Japan comments on *REESS Vibration Test*

EVS-GTR IWG#18_June, 2019 @ Tokyo

From data of 22 vehicles

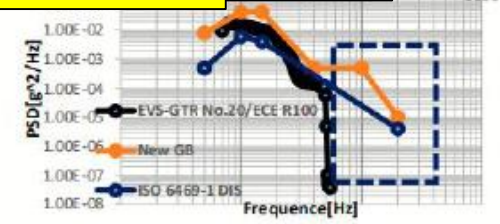
- There are still load strength above 50Hz, which should not be ignored
- Vibration loads in x and y directions are almost 50%-70% of the loads in z direction, which should not be ignored

Feedback points in China's presentation.

- There are lots of pack design whose dominant frequency is higher than 50Hz especially for PHEV and HEV.
- It is very hard for current EVS GTR vibration profile to expose these pack's design defect.

Japan test data* ([Double logarithmic plot](#))

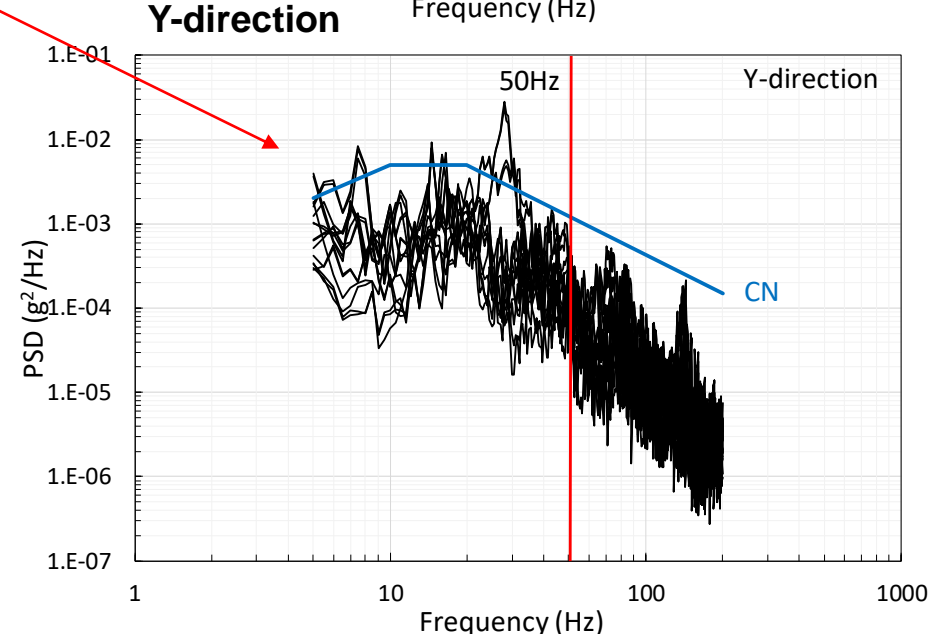
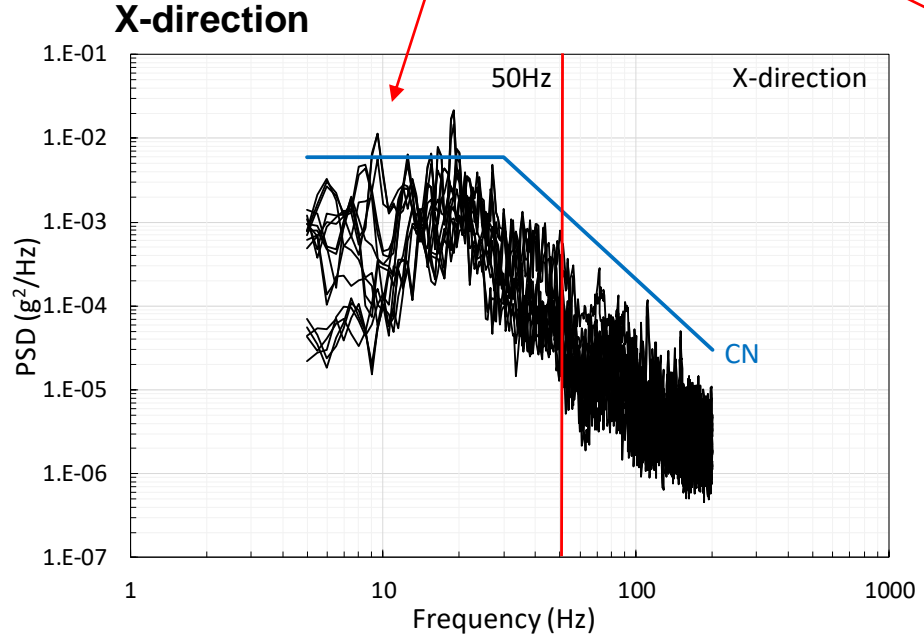
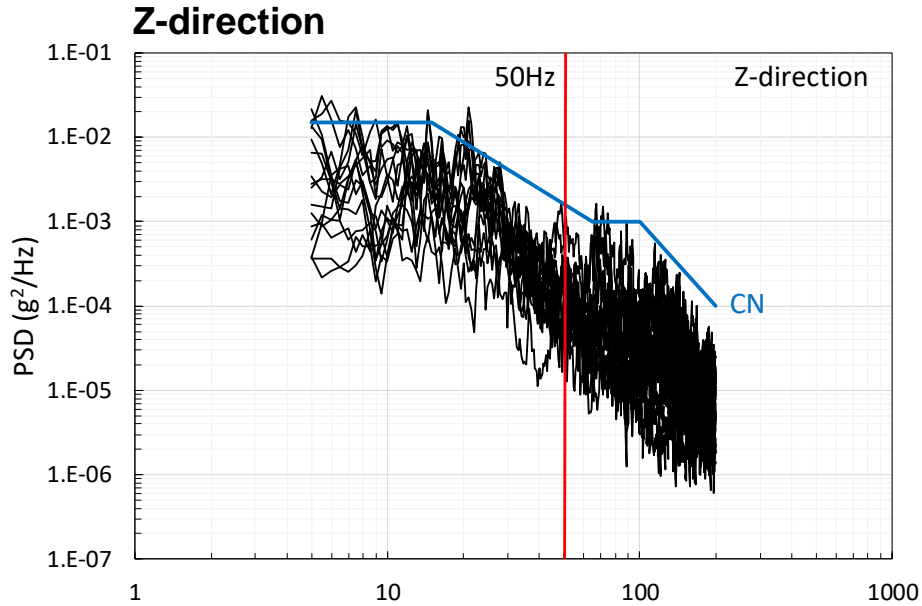
Other than Z-direction, vibration input from X- and Y-direction exist.

Japan test data* ([Real number plot](#))

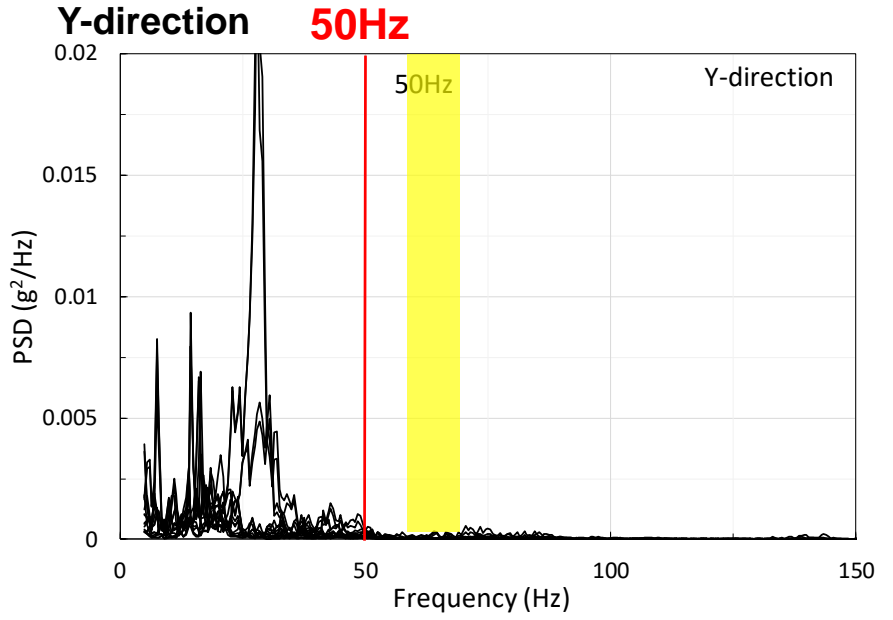
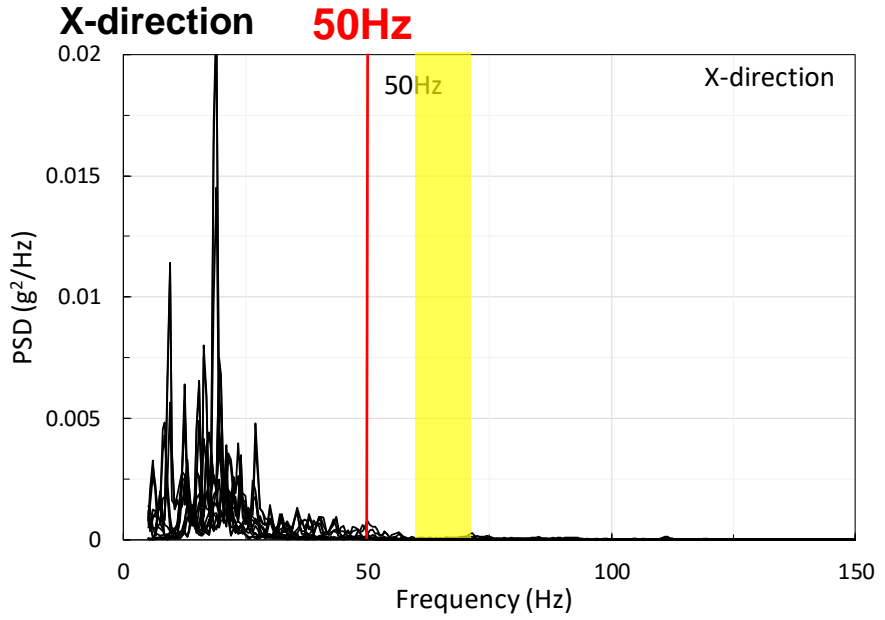
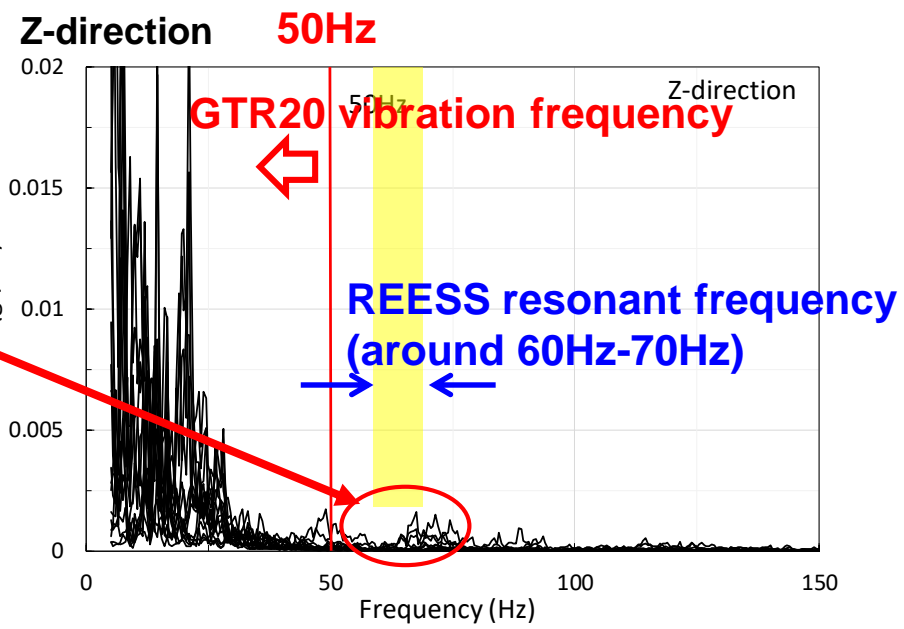
- Vibration at around 70Hz exists.
- REESS resonant frequency is about from 60Hz to 70Hz according to China test data.

Justification to limit the vibration test frequency below 50Hz is not sufficient.

Test data differences

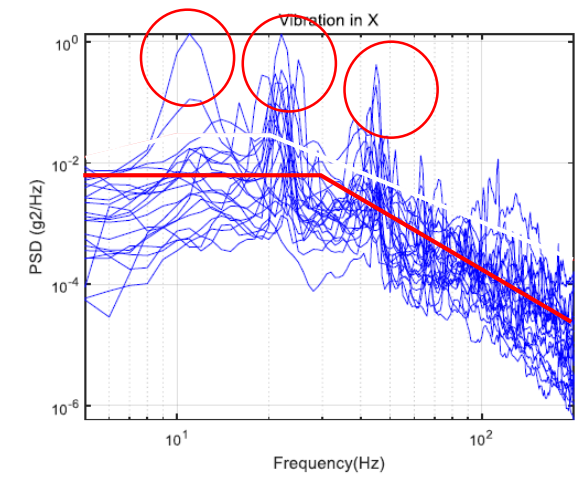
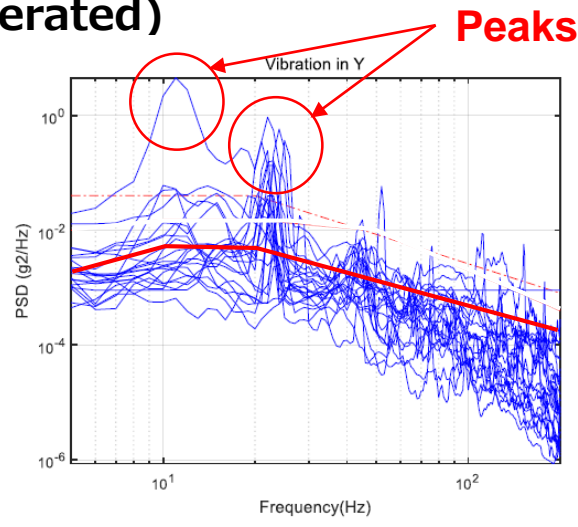
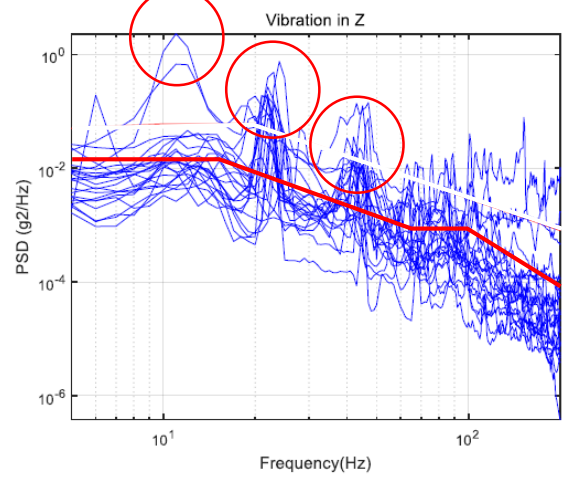
China data is higher than Japan data and some peaks at several frequencies are observed. → Detailed analysis to identify the cause of differences are necessary.

Procedure 3—data normalized

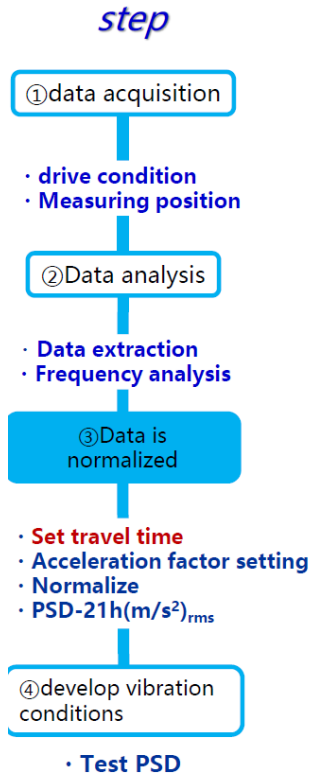
Assumption of lifetime mileage affects test time for durability evaluation and usually varies with vehicle type, market and manufacturer.

Durability evaluation should not be the purpose of GTR's vibration test (see Page 10).

Data Collection and Analysis

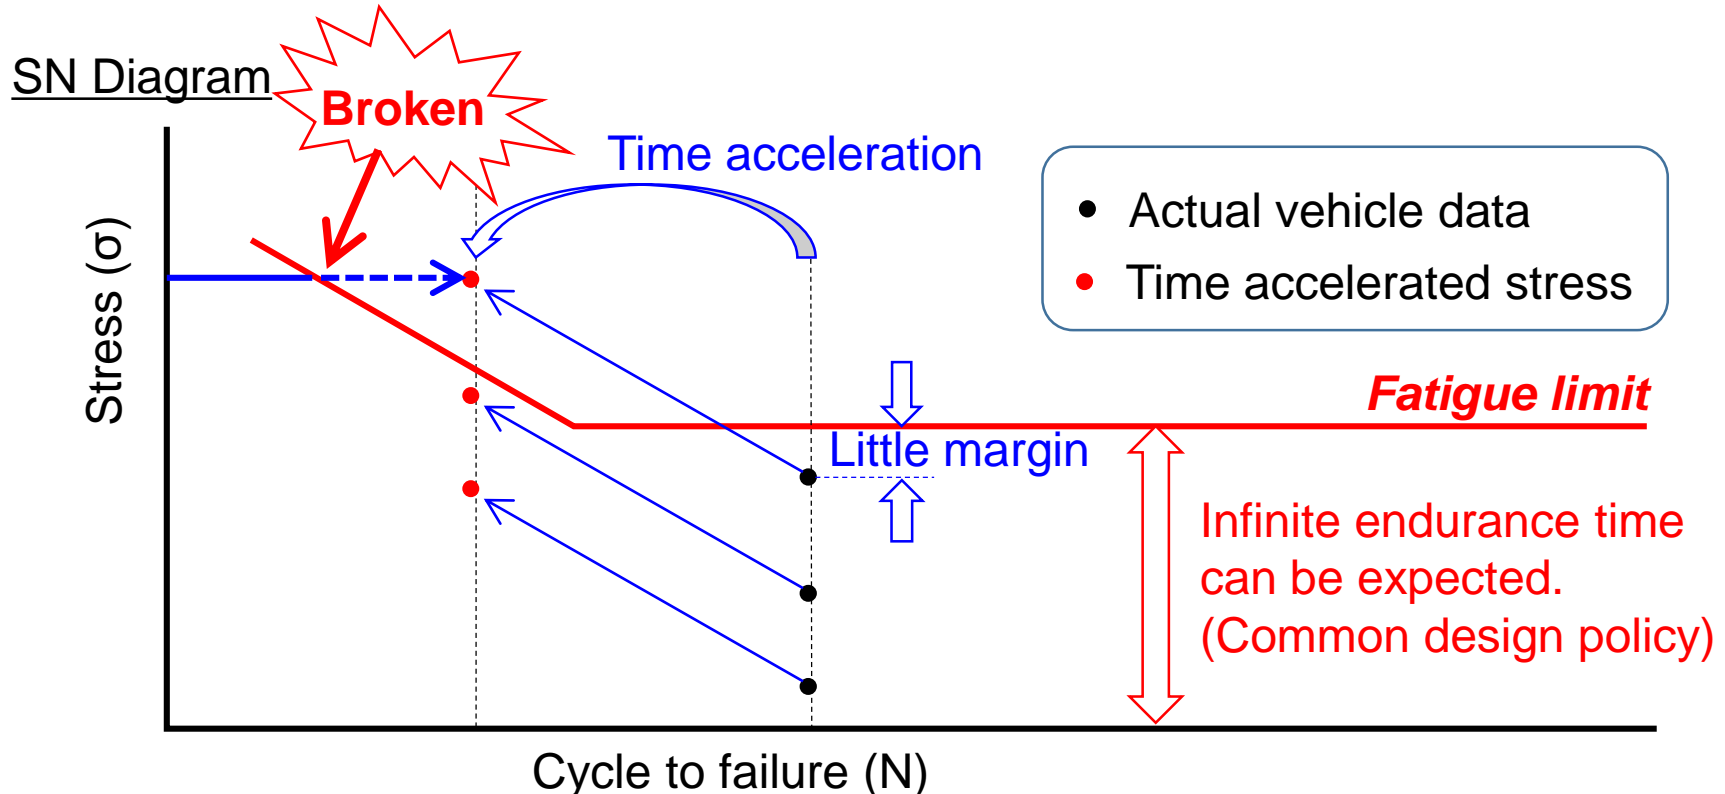
Very limited and severe driving condition

Continuous driving on a same corrugation road for 1hr at 50km/h is not practical in real world situation.
